**COOPER NUCLEAR STATION**

**QUALITY ASSURANCE PROGRAM**

**FOR OPERATION POLICY DOCUMENT**

REVISION 12 - SUMMARY OF CHANGES

FIGURE 1

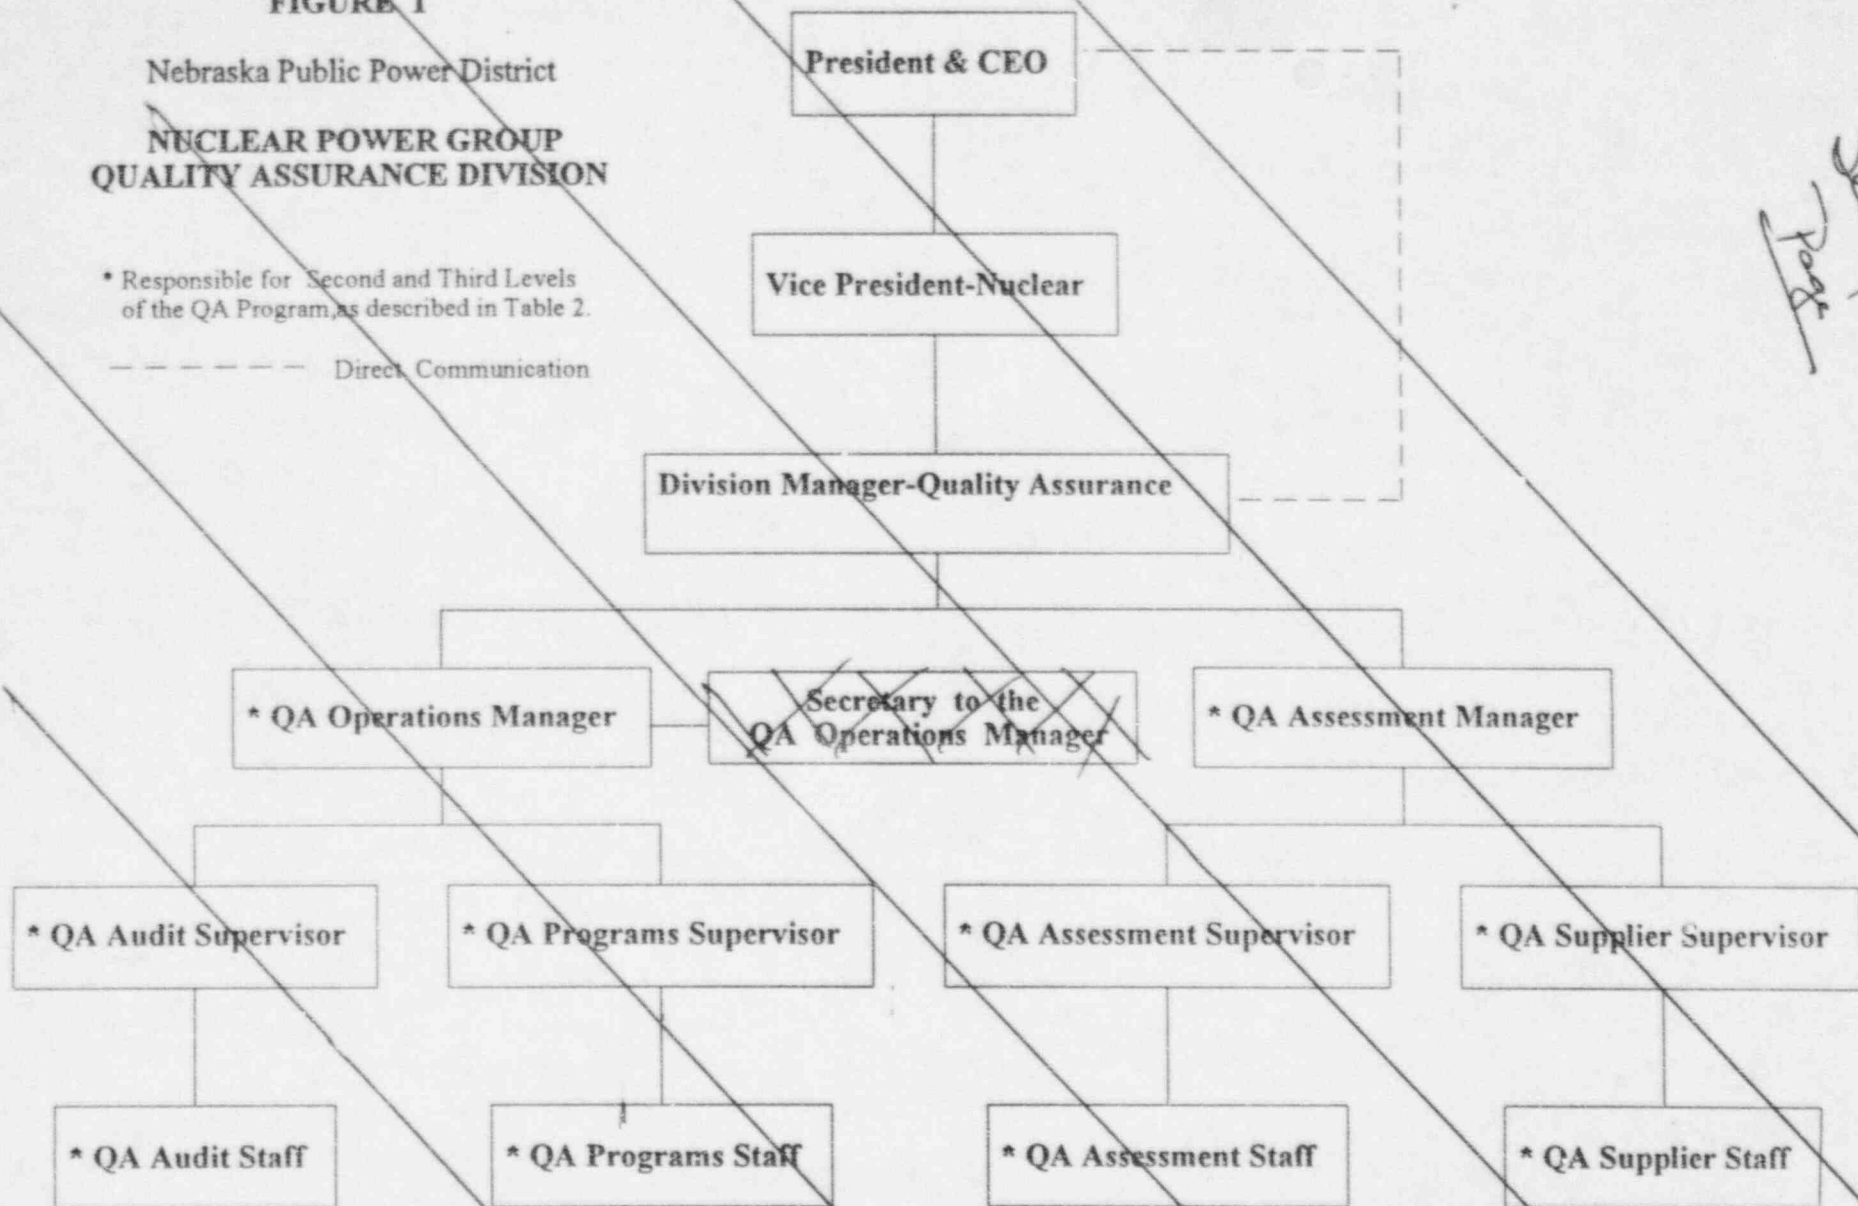
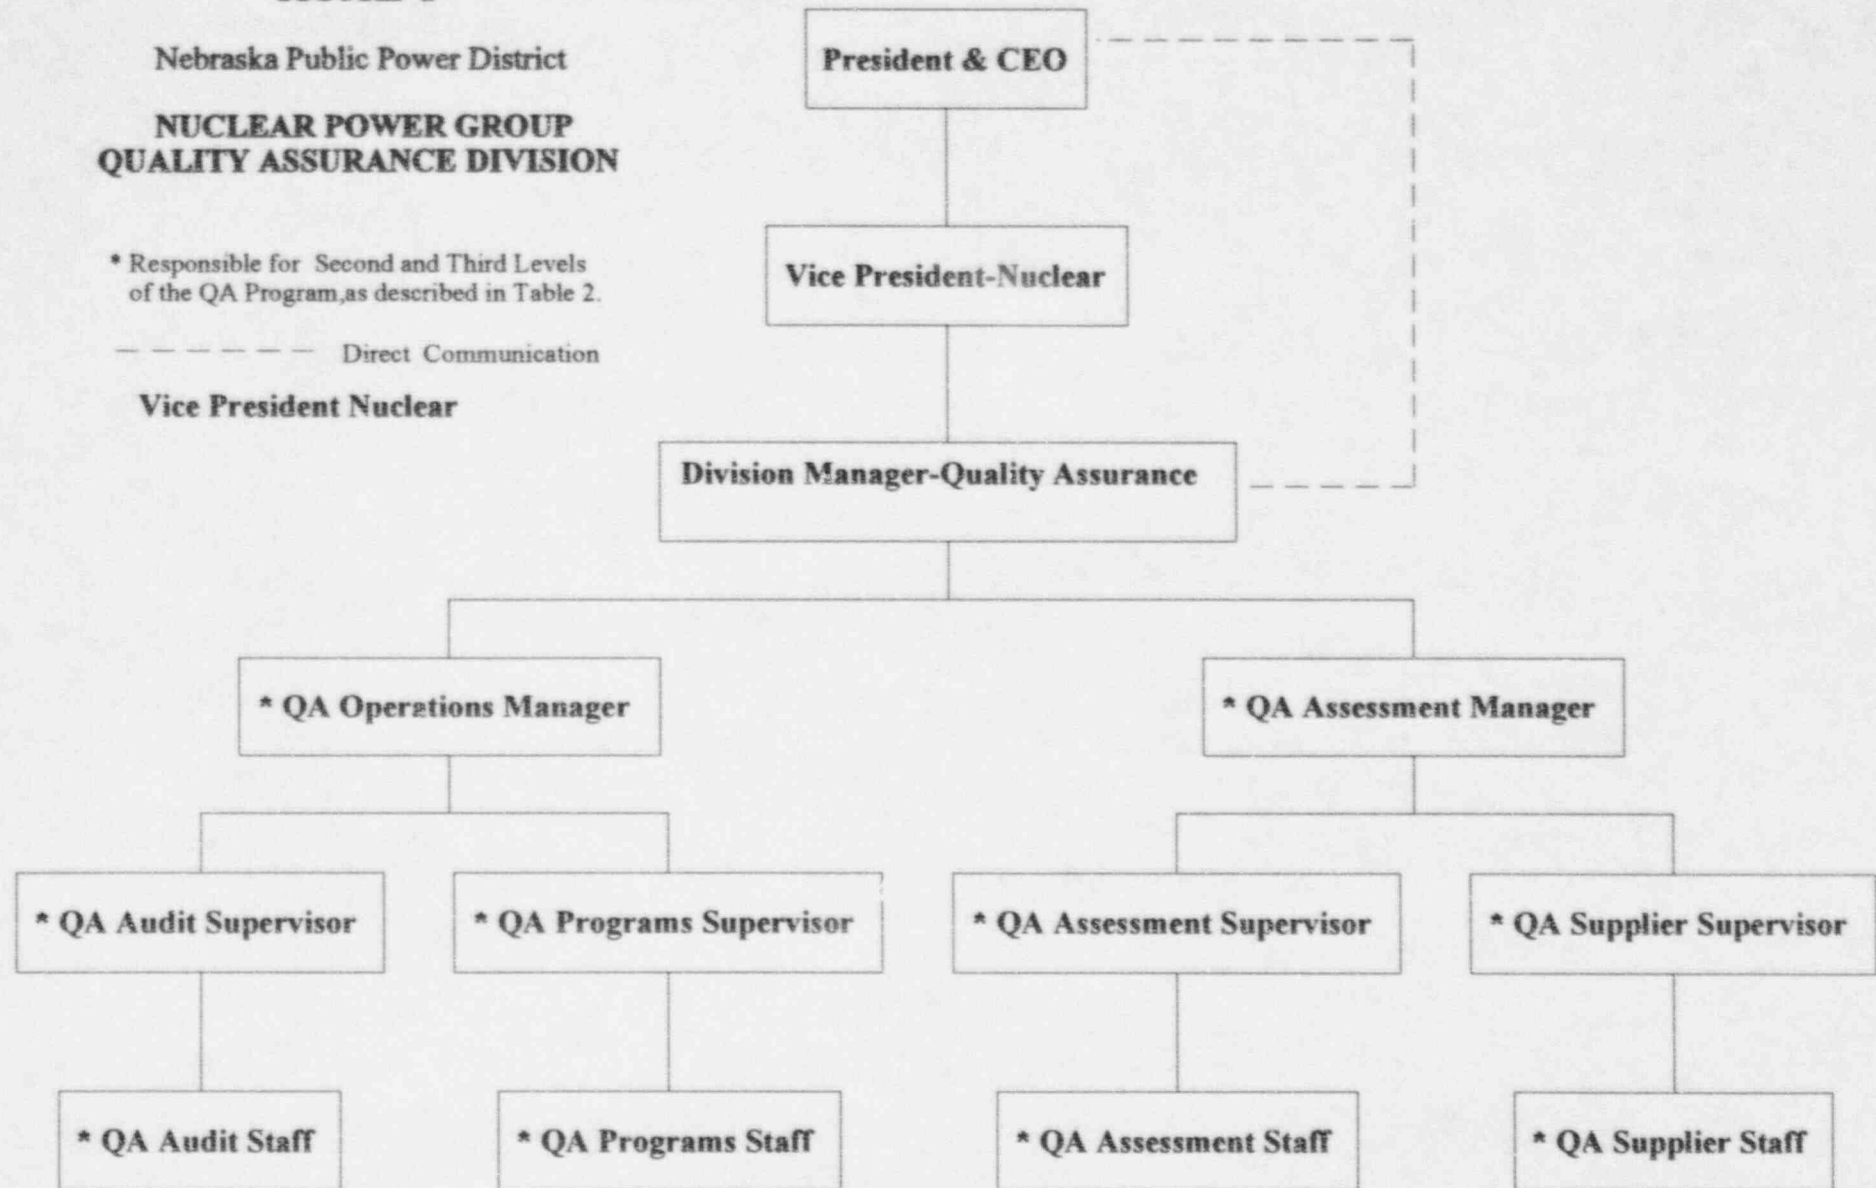
Section/ Paragraph	Change Descriptions	Commitment Reduction?
Figure 1 Page 8-1	The organizational chart is revised, consistent with specific changes contained in this Document revision, and as herein described. The organizational changes do not constitute any reduction in the levels of Quality Assurance Program responsibility or implementation, and therefore do not change previous commitments.	No
Table 2 Page 9-5 Section a)	Clarified the statement that QC Inspectors must be independent of job site supervision. This is consistent with the commitment clarification/exception for application of ANSI N45.2.6, as stated in section 2.10, item 1.(a). Therefore this clarification does not constitute a reduction of commitment.	No
Table 2 Page 9-5 Section c) Para. 1	Editorial improvements are made to the first sentence to clarify responsibility of the QA Staff for applying Divisional techniques (audit, surveillance, and evaluation) to activities which affect quality. This clarification encompasses the previous statement and is therefore not a reduction of commitment.	No
